Office Action Summary

10/085,649

WHITTON ET AL.

DETAILED ACTION

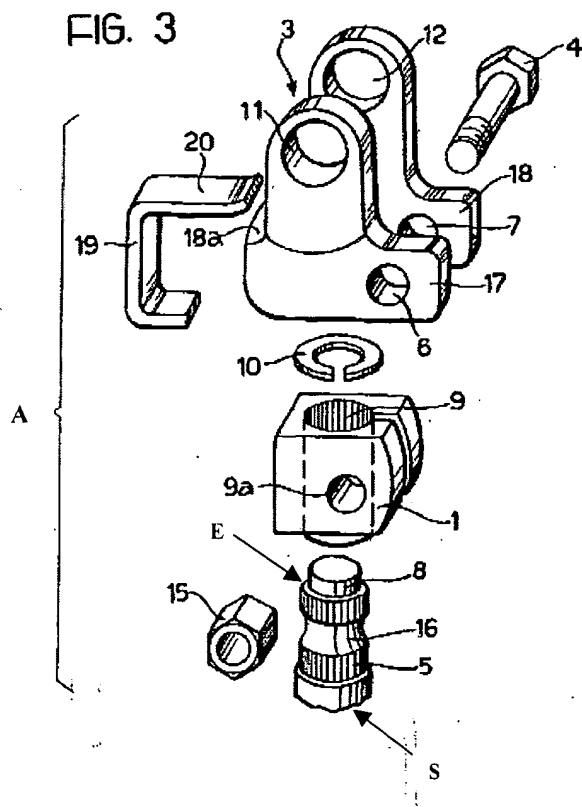
a. Claim 1. Pinna clearly discloses a shaft **S** configured for interconnection with a coupling element **1**, the shaft **S** comprising an axial shaft body **5** having upper and lower surfaces and terminating in a forward end **E**; a bolt receiving recess **16** in the upper shaft surface adjacent the forward shaft end **E**; and at least one projection **8** extending from the shaft forward end **E** adjacent the shaft upper surface (see annotated figure 3 below;).

- b. Claim 2. Pinna further shows the shaft body **5** having a given cross-sectional area and the projection **8** having a cross-sectional area substantially less than the [shaft body **5**] cross-sectional area (see annotated figure 3 above).
- c. Claim 8. Pinna also shows the bolt receiving recess **16** is an annular groove (see annotated figure 3 above).

b. Claim 10. Pinna further shows the shaft-receiving slot **9** having a given cross-sectional area, the shaft body **5** having a cross-sectional area substantially equal to the [shaft-receiving slot **9**] cross-sectional area and the projection **8** having a cross-sectional area substantially less than the [shaft-receiving slot **9**] cross-sectional area (see annotated figure 3 above).

c. Claim 18. Pinna further shows the bolt receiving recess **16** as an annular groove (see annotated figure 3 above).

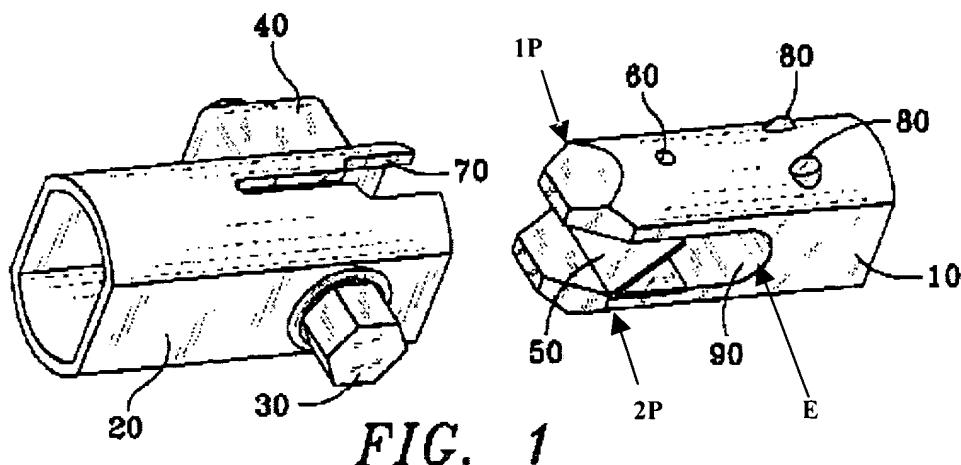
a. Claim 4. Pinna, as applied to claim 1 above, discloses a projection **8** extending from the shaft forward end adjacent the shaft lower surface, but fails to disclose a second projection substantially opposed to the projection **8** extending adjacent the shaft upper surface with an open space defined therebetween. Wey, however, teaches a second projection **2P** extending from a shaft forward end adjacent a shaft lower surface, the second projection **2P** substantially opposed to the projection **1P** extending adjacent the shaft upper surface with an open space **90** defined therebetween to provide flexible prongs (see annotated figure 1 below). Therefore, it would have been obvious to one having ordinary skill in the art at the time the invention was made to modify the projection of Pinna to include a second projection opposed to the first projection with an open space therebetween as taught by Wey.

c. Claim 6. The combination of Pinna and Wey, as applied to claim 4 above, includes a shaft body **5** having a given cross-sectional area and the first **1P** and second **2P** projections having a cross-sectional area substantially less than the [shaft body **5**] cross-sectional area (see Pinna annotated figure 3 above and Wey annotated figure 1 above; see also subparagraph 6(b) above).

a. Claim 13. Pinna, as applied to claim 9 above, discloses a projection **8** extending from the shaft forward end adjacent the shaft lower surface (see annotated figure 3 above), but fails to disclose a second projection substantially opposed to the projection **8** extending adjacent the shaft upper surface with an open space defined therebetween. Wey, however, teaches a second projection **2P** extending from a shaft forward end adjacent a shaft lower surface, the second projection **2P** substantially opposed to the projection **1P** extending adjacent the shaft upper surface with an open space **90** defined therebetween to provide flexible prongs (see annotated figure 1 above). Therefore, it would have been obvious to one having ordinary skill in the art at the time the invention was made to modify the projection of Pinna to include a second projection opposed to the first projection with an open space therebetween to provide flexible projections as taught by Wey.

- b. Claim 14. The combination of Pinna and Wey, as applied to claim 13 above, includes flexibility in the [first] and [second] projections.
- c. Claim 15. The combination of Pinna and Wey, as applied to claim 13 above, includes the shaft-receiving slot **9** having a given cross-sectional area, the shaft body **5** having a cross-sectional area substantially equal to the [shaft-receiving slot **9**] cross-sectional area and the first **1P** and second **2P** projections having a combined cross-sectional area substantially less than the [shaft-receiving slot **9**] cross-sectional area (see Pinna annotated figure 3 above and Wey annotated figure 1 above).
